Docket Nos. 50-269

Our review of recent submittals regarding the reevaluation of emergency core cooling system (ECCS) performance in accordance with 10 CFR 50.46 indicates that certain additional information was required in order for us to complete our evaluation. This letter is to inform you of one part of the evaluations that have been submitted that has required additional information.

ORDER FOR MODIFICATION OF LICENSE

## APPENDIX A

FIGURE A-4

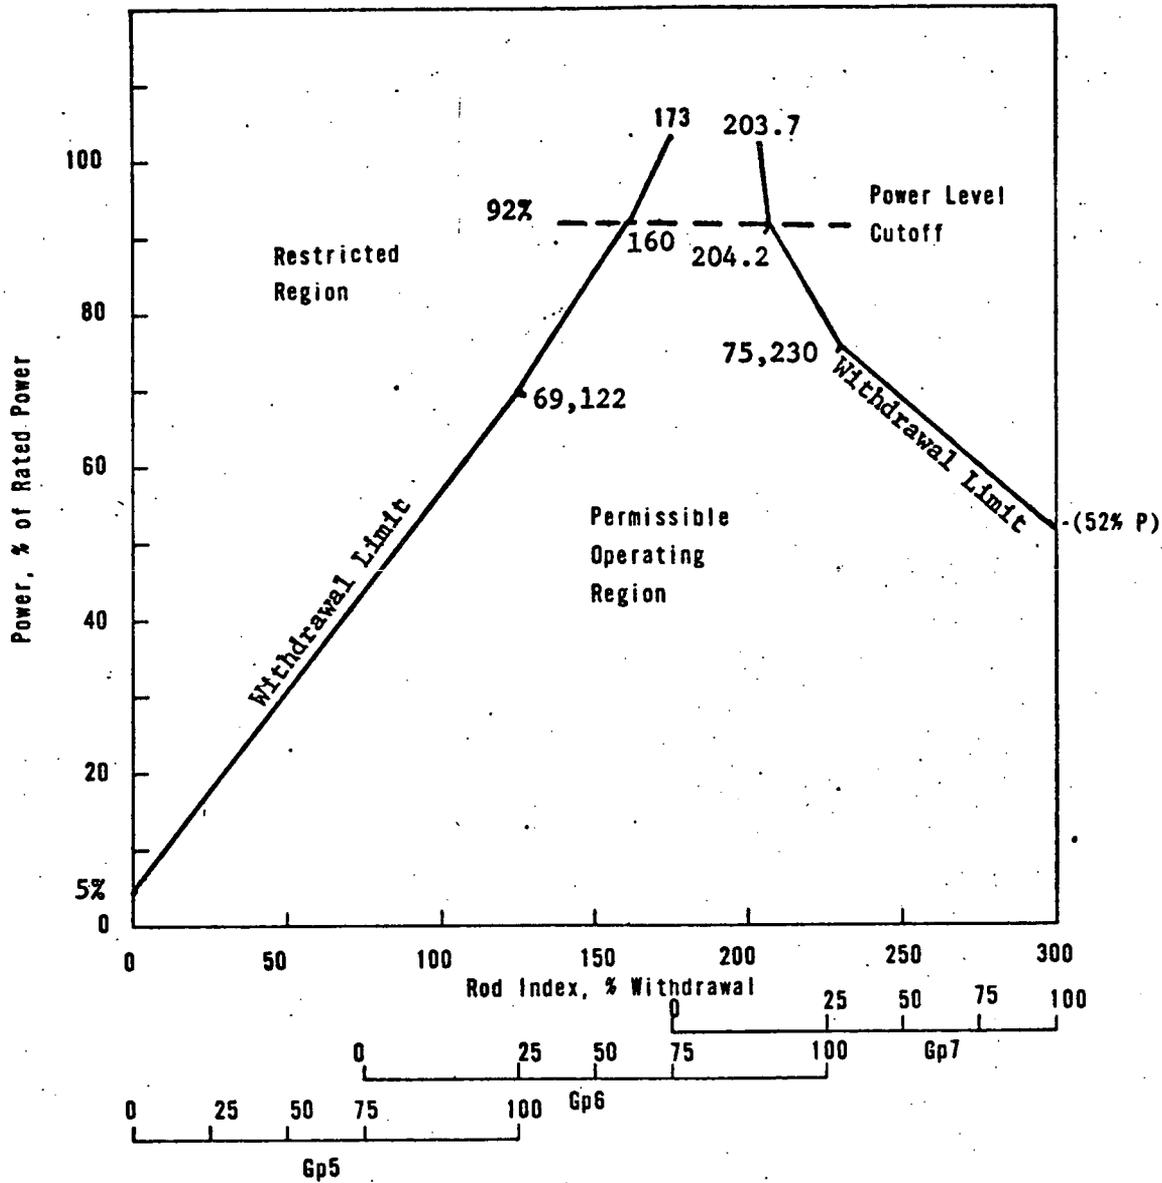
2. Power level shall not be greater than 92 percent (power level cutoff) unless one of the following requirements is met:
  - a. Quadrant tilt is less than or equal to 2.5 percent and the xenon reactivity is within 10 percent of the value for operation at steady-state rated power.
  - b. Quadrant tilt is greater than 2.5 percent and the xenon reactivity is within 5 percent of the value for operation at steady-state rated power.
3. Operation shall be within the control rod withdrawal limits as shown in Figure A-4.
4. Operation shall be within the power imbalance envelope as shown in Figure A-5.
